# Implementors' Guide for ITU-T Recommendation G.168 (issue 2)

This document contains technical corrections and clarification for the implementation of ITU-T Recommendation G.168 (06/02). This is an updated version of the Implementor's Guide, issue 1 (January 2003).

Figure 13/G.168 - Test No. 2C signal and time relationships

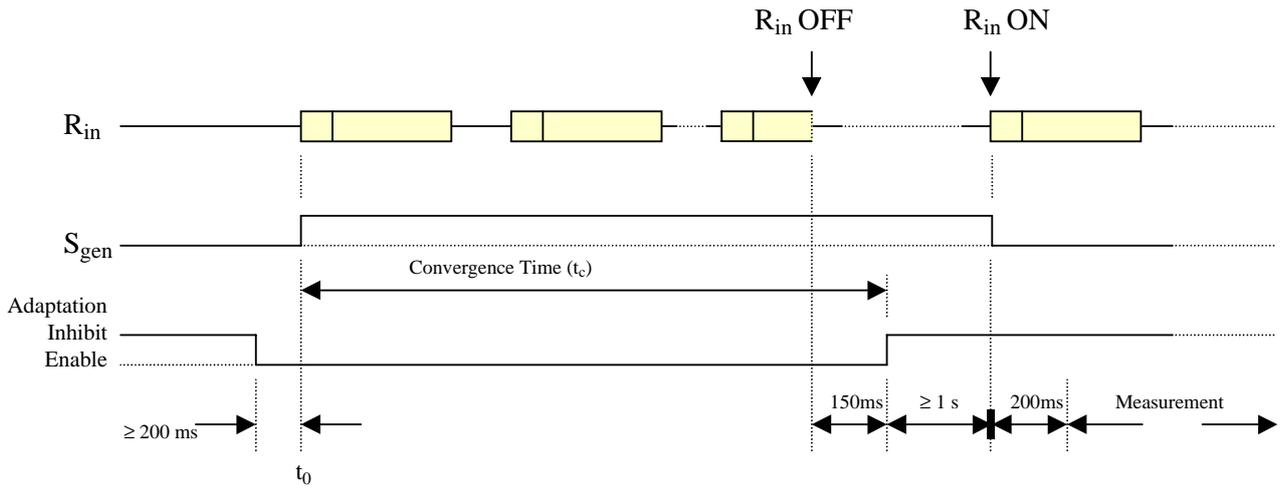
- Add  $t_0$  to Figure 13/G.168
- The convergence time allowed in Test 2C part (c) is 10
- The requirements graph in Figure 16/G.168 should be truncated after  $10s + t_d$  since the steady state requirement for Test 2C is given in part (b)
- Add the following note under part (c):

In ITU-T Recommendation G.168 (06/02), a small change to the test method for Tests 2C(a), 2C(b), 3A and 3B has required the timing diagrams for these tests to be redrawn relative to the G.168 (04/00) version of the tests. In the earlier diagrams for Tests 2C and 3A, a delay was indicated between terminating the  $S_{gen}$  noise and starting the measurement of the signal at  $S_{out}$ . This delay is necessary if the level measurement device of section 6.4.1.2.1/G.168 is used for the measurements at  $S_{out}$ , otherwise  $S_{gen}$  noise energy stored in the bandpass filter and exponential filter of this measurement device will encroach into the measurement interval.

- A delay to the start of the measurement interval is re-introduced into the timing diagrams for Test 2C and also for Tests 3A and 3B if the 6.4.1.2.1 measurement method is used. The energy stored in the bandpass filter will propagate out in less than 13ms. The output from the exponential filter will decay by about 23dB in 187ms. Therefore, a total delay of 200ms before starting the measurement is more than adequate for tests 2C and 3A. This is shown in the modified Figures 13 and 17.

**Figure 18/G.168 - Test No. 3B signal and time relationships**

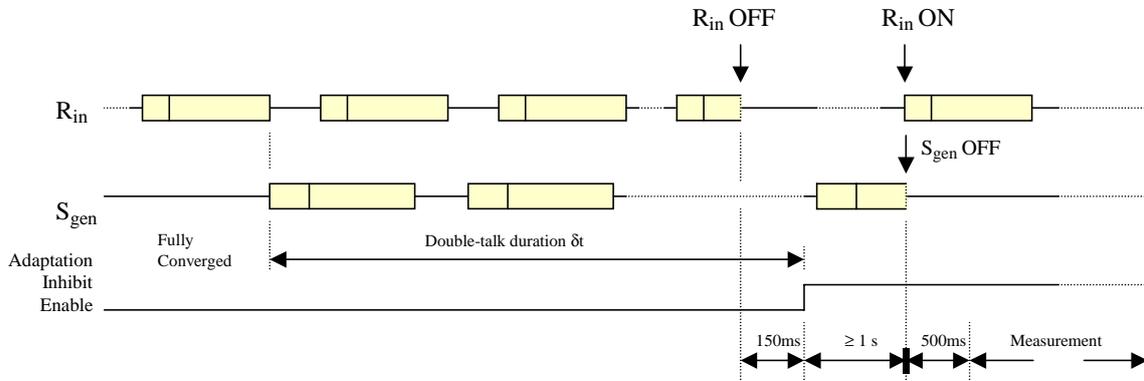
For Test 3B, the longest measurement delay is required when the test levels are  $L_{S_{gen,act}} = 0\text{dBm0}$  and  $L_{R_{in,act}} = -30\text{dBm0}$ , and  $L_{RES}$  is at the threshold of failure ( $-45\text{dBm0}$ ). In this situation, when the signal at  $S_{gen}$  is discontinued, the signal at  $R_{in}$  is reinstated and will rapidly exert an influence if echo path delay,  $t_d$ , is low. The output from the exponential filter will decay towards  $L_{RES}$ , becoming asymptotic to that level. Thus, to guarantee a pass result, in theory an infinite delay would be required before starting the measurements. In practice, bearing in mind that such a test result represents a borderline failure in any case, it is sufficient to ensure that the output from the exponential filter decays to a value indistinguishable from  $L_{RES}$  because of fundamental limitations due to noise and resolution. It is suggested that the chosen delay should allow the output from the exponential filter to decay, theoretically, to within 0.2 dB of  $L_{RES}$ . A total delay of 400ms (which includes 13ms to clear the history in the bandpass filter) would only allow the output from the exponential filter to decay to 1.76 dB of  $L_{RES}$ , and so this value of delay is insufficient. A total delay of 500ms (including 13ms to clear the history in the bandpass filter) would allow the output

from the exponential filter to decay to 0.12 dB of  $L_{RES}$ , and so represents a suitable delay to the measurements. Hence Figure 18/G.168 is modified to show a delay of 500 ms between terminating the  $S_{gen}$  noise signal and starting the measurement of the signal at  $S_{out}$ .

**Figure 22/G.168 - Performance requirements for test 7**

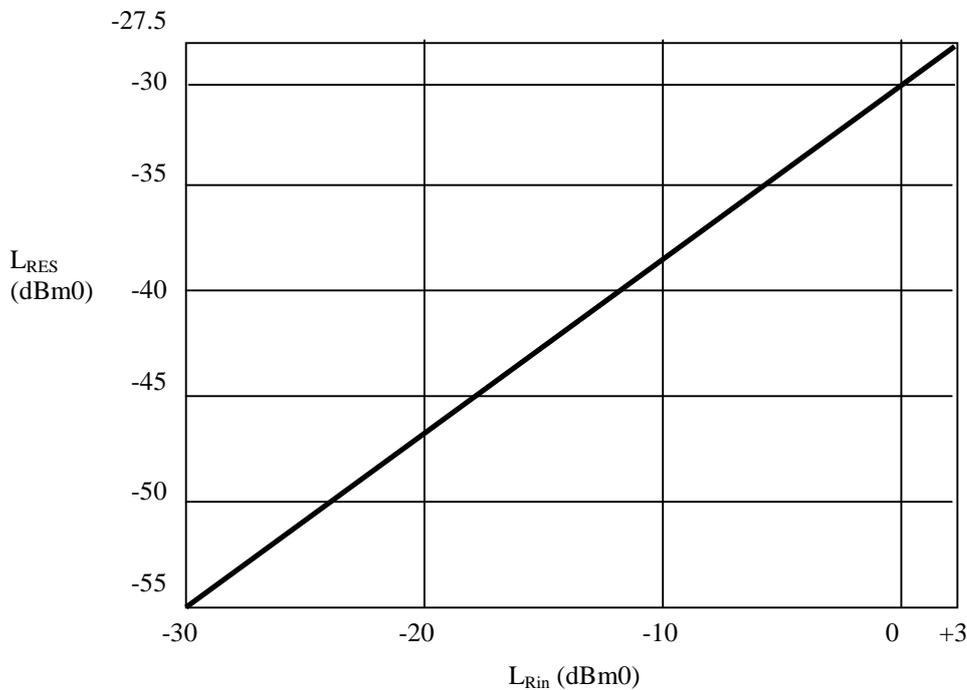
The requirements for Test No. 7 are given in Figure 22/G.168. This graph gives  $L_{RES}$  plotted against  $L_{Rin}$ . The graph is intended to be a straight line between the following two co-ordinates:

The graph in Figure 22 is correct at these two points, but due to unequal spacing, is incorrect everywhere else. Figure 22 should therefore be deleted and replaced with the following:

Note that the equation for the line in Figure 22 is:  $L_{RES} = 0.83L_{RIN} - 30$
